Clunking Noise on 2007-2012 Mazda 2.3 & 2.5L Engines

The AERA Technical Committee offers the following information regarding a clunking noise coming from the engine compartment on 2007-2012 Mazda 2.3 & 2.5L engines. This clunking noise has been reported more so in areas with higher ambient temperatures, such as the in the state of Arizona.

Figure 1. Number 3 Rubber Motor Mount (A)

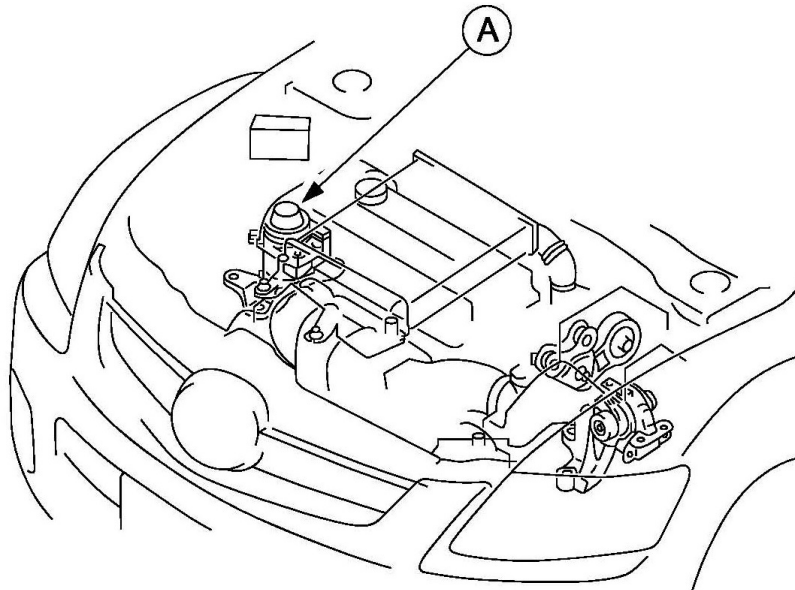
Some vehicles may exhibit a clunk noise from the engine compartment when driving over rough roads or over a speed bump. It has been determined that due to high heat, the lubricant inside the No. 3 engine mount rubber (See A in Figure 1) may become ineffective, causing a stick-slip noise between the casing and the rubber. There is however, no oily seepage from the engine mount.

When replaced, the new engine mount rubber uses a new type of lubricant to eliminate this concern. Customers having this concern should have their vehicle repaired using the following repair parts available from Mazda.
